# Economic and Social Council

## Proposal for 02 series of amendments to UN Regulation No. 160 (Event Data Recorder)

### Submitted by the Working Party on General Safety \*

Corridor +/- 10 Per Cent of the Full-Scale Range of the Accelerometer

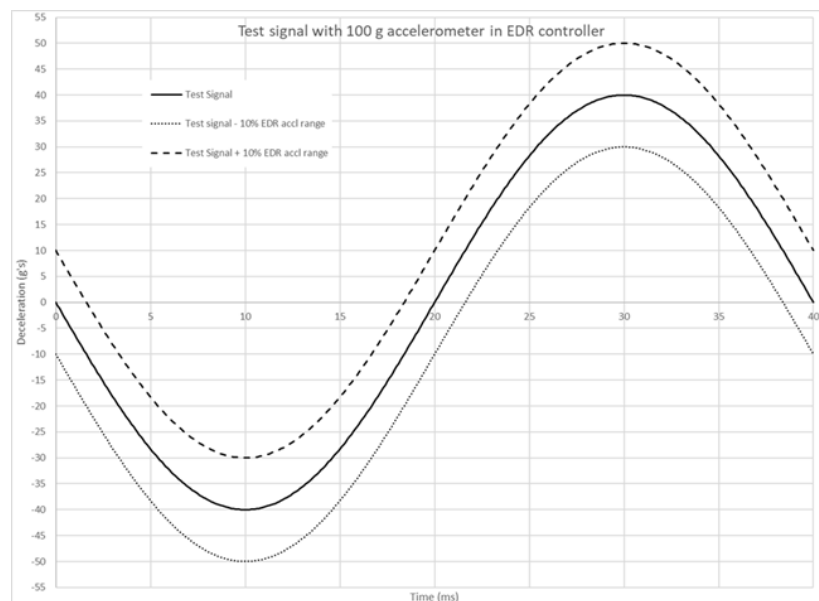
6.1.5. The EDR recorded acceleration trace shall be fully contained in a corridor that is +/- 10 per cent of the full-scale range of the accelerometer used by the controller containing the EDR applied to the component test fixture's filtered acceleration trace. The comparison of acceleration sensor traces shall only be made on the axis the component test was conducted.

For example, if the accelerometer in the controller containing the EDR function has a +/- 100 g range, then +/- 10 g would be applied to the component test fixture's filtered acceleration trace. The EDR recorded acceleration trace shall be fully contained within that corridor (see the figure).

## "Annex 3

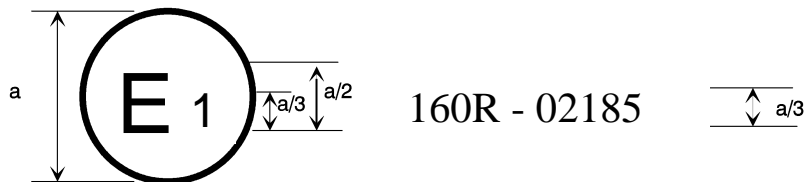
Annex 3, amend to read:

The above approval mark affixed to a vehicle shows that the vehicle type with regard to its EDR concerned has been approved in Germany (E 1) pursuant to UN Regulation No. 160. The first two digits of the approval number (02) indicate that the approval was granted in accordance with the requirements of the 02 series of amendments to UN Regulation No. 160.
